MITSUBISHI MOTOR SALES OF AMERICA, Inc.

TECHNICAL SERVICE BULLETIN

1989 MONTERO V-6 REAR SUSPENSION BUSHING CHANGE

NO.	TSB-89-17-001
DATE	January, 1989
MODEL	Montero

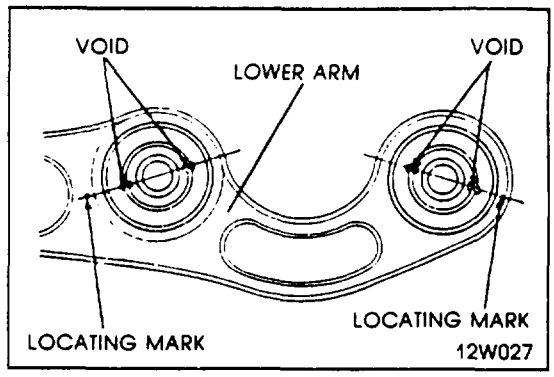
2. Whereas the old style could be installed without regard to direction, the new style must be installed with the openings (voids) in specific locations.

On vehicles with the new style bushings installed at the factory, marks have been made in the lower arm for correct installation. When replacing inese bushings, align the voids with the marks as shown.

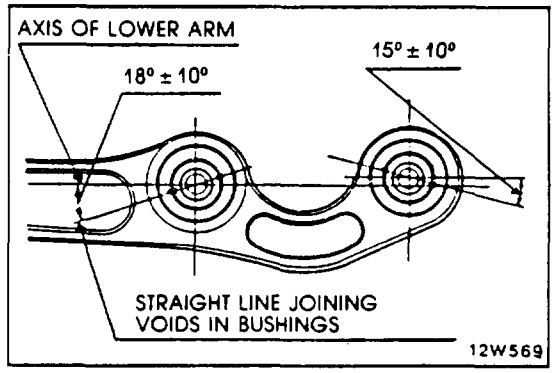
On vehicles with the old style bushings installed at the factory, no marks were made on the lower control arm. When installing new style bushings in older lower control arms without marks, the new bushings should be installed at the angles indicated.
